NETWORK RAIL (CAMBRIDGE SOUTH INFRASTRUCTURE ENHANCEMENTS) ORDER

MAIN PROOF OF EVIDENCE ON MATTERS OF TRANSPORT

GRAHAM HUGHES ON BEHALF OF THE UNIVERSITY OF CAMBRIDGE

Inquiry Document Reference	[TBC] /OBJ 8
Author	Graham Hughes
Date	6 January 2022

Figures 2 and 3: Site construction compounds
(taken from Environmental Statement)

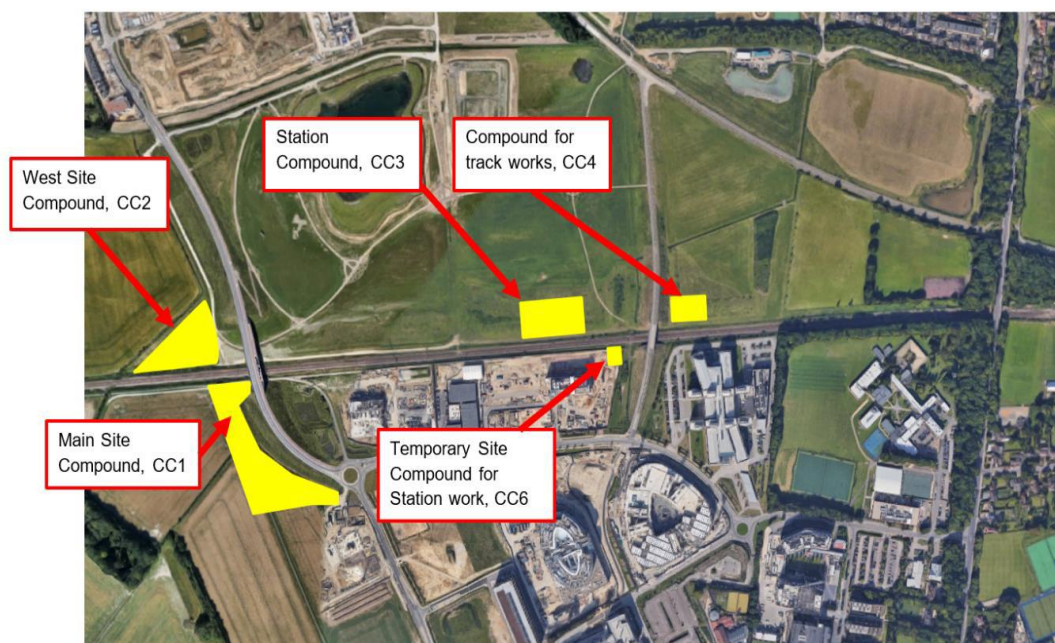
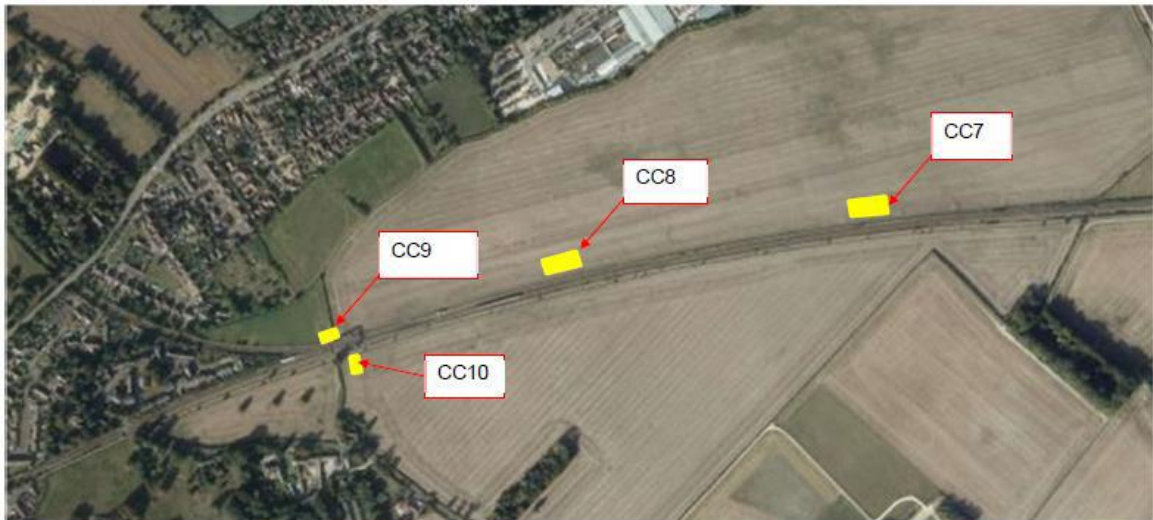
- 5.2 Paragraphs 17.4.3 – 17.4.24 of the Environmental Statement outline the proposed approach to assessing construction impacts and mitigation based upon the proposed locations of haul roads and site compounds. This contains measures for managing the impacts during construction as a result of activities. In reality, these proposals amount to no more than good practice and what would be adopted on any major construction site to manage impacts. The proposals for management and mitigation do not reflect the special circumstances of the AMB and potential uses on Plot 9 (as set out in the evidence of other experts for the University, including Mr Karl Wilson and Mr Paul Milliner) and in particular, the extremely sensitive nature of the research that takes place there.

- 5.4 In my view, whilst the access roads, haul roads and construction compounds all appear to be sensible from a construction perspective, there is no meaningful discussion in the ES of alternatives that have been considered and alternative forms of mitigation that could be adopted beyond good operational practice for responsible contractors to minimise impacts. Given the significance of the receptors in the AMB, I would have expected that options would have been considered to demonstrate that in Network Rail's view, the suggested approach has an acceptable level of impact and that level of impact can be maintained throughout the construction period for the proposed Scheme. This, in my view, is an omission and given the sensitivity of the AMB, until resolved, will remain an objection of the University to the proposed Order.

- 5.5 I do acknowledge that given the rail line is a linear piece of infrastructure and the station buildings are proposed on both sides of the track, construction access and site compounds are likely to be required on both sides of the tracks; constructing from one side only, is likely in my opinion to not be feasible. However, that does not in my view, remove the responsibility for Network Rail, through the ES to effectively and accurately, assess impacts on key receptors, identify and assess alternative methodologies or management strategies to those proposed and identify how best as a result, those impacts can be mitigated. I would expect that to be a key part of the ES and in my opinion, that has not been adequately covered.

- 5.7 I would therefore expect the following elements to be included in the ES:
- 5.7.1 identification of any alternatives that had been considered for the proposed access roads, haul roads and construction compounds currently identified and why those selected have been chosen;

- 5.7.2 for both the current and any alternatives proposed, considerations of any further mitigation that could be applied to reduce the noise and vibration impacts to acceptable levels on key receptors such as the AMB. In particular, I would wish to see details of how any assessed impacts in terms of noise and vibration can be guaranteed to be maintained so the University can have confidence that the impacts will not change and potentially become unacceptable throughout the period of the construction. In this regard, I would expect to see full details of how the haul roads and construction compounds will be constructed including materials used and any measures in the construction methodology to reduce impacts. However, just as important as this is how those haul roads and construction compounds will be maintained in their original state, and this applies to the wider access network too. This is because the likely noise and vibration impacts from roads that are poorly maintained will be greater and so to minimise the likely impacts, they need to be maintained well;

- 5.7.4 for the haul roads and construction compounds, I would expect a similar approach. These will be created specifically for the works and so I would expect to see details of how they will be constructed, and the materials used and a similar monitoring regime and process for repair of any defects that occur, to be agreed by the University prior to works commencing; and
